LANDMARK INDUSTRIAL PARK SUBDIVISION,
UNIT III, RESUBDIVISION OF LOTS 4 & 5

APPLICATION NUMBER 14 DATE June 7, 2007

LANDMARK INDUSTRIAL PARKSUBDIVISION, UNIT 3, RESUBDIVISION OF LOTS 4 AND 5

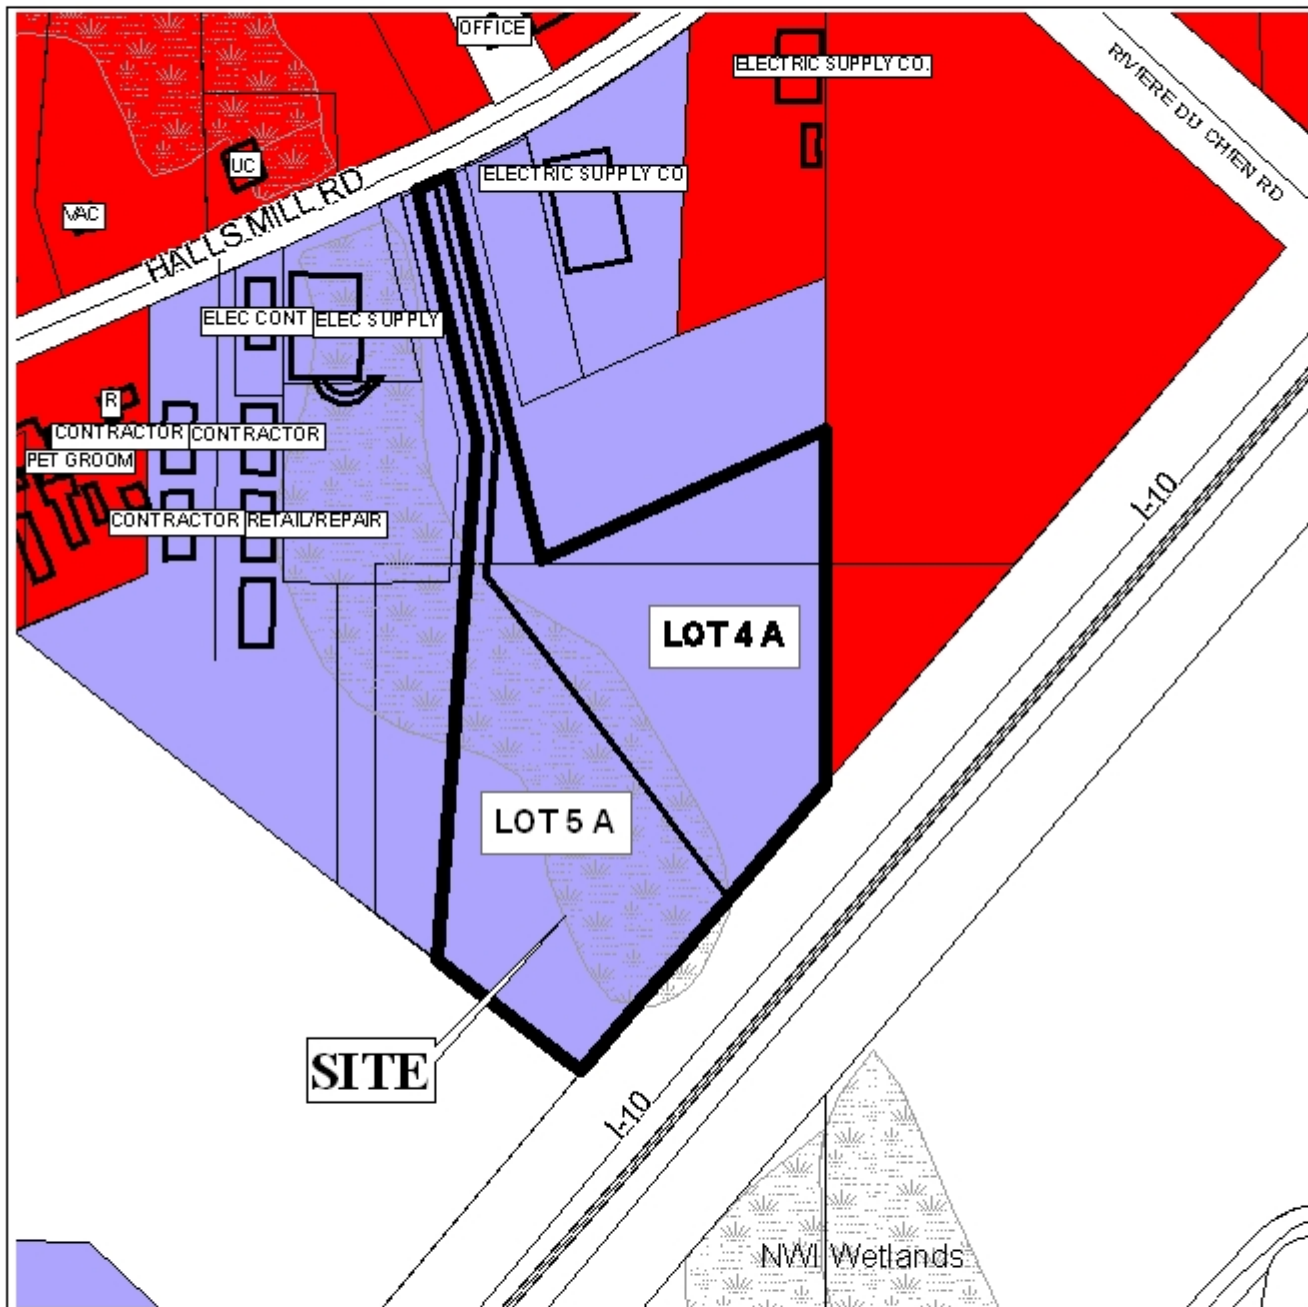
The site fronts Halls Mill Road, which has an existing right-of-way of 60-feet, is a collector street and as such requires a 70-foot right-of-way; therefore, dedication of sufficient right-of-way to provide 35-feet from the centerline should be required.

The plat illustrates two flag-shaped lots (Lots 4A, and 5A), which are typical of the previously approved subdivision (Landmark Industrial Park, Unit 3); however, these lots would require a waiver of Section V.D.3. (Maximum Depth) of the Subdivision Regulations.

The final plat should also illustrate the building setback for the flag-shaped lots at the point where each lot is at least 60 feet wide.

It should be noted that the prior approval required a note on the Final Plat stating that there would be no further resubdivision of the property was to not allow additional lots; however, as this preliminary approval is simply to shift interior property lines between adjacent lots the integrity of the original condition would be maintained. A note on the Final Plat stating that

there would be no further resubdivision of the property to increase the number of lots should be required.

The site is in a floodplain and as such the area may be considered environmentally sensitive; therefore, the approval of all applicable federal state and local agencies would be required.

With a waiver of Section V.D.3. (Maximum Depth), the plat will meet the minimum requirements of the Subdivision Regulations and is recommended for Tentative Approval, subject to the following conditions:

- 1) dedication sufficient to provide 35 feet from the centerline of Halls Mill Road;
- 2) the placement of a note on the Final Plat stating that an Administrative Planned Unit Development application must be submitted as lots are developed, to provide for shared access between lots;
- 3) the placement of a note on the final plat stating that there will be no further resubdivision of the lots to increase the number of lots;
- 4) the placement of the setback lines on the final plat where the flag-shaped lots are at least 60 feet wide; and
- 5) the placement of a note on the Final Plat stating approval by all applicable federal, state, and local agencies will be required prior to the issuance of any permits, due to the site's location in the floodplain.
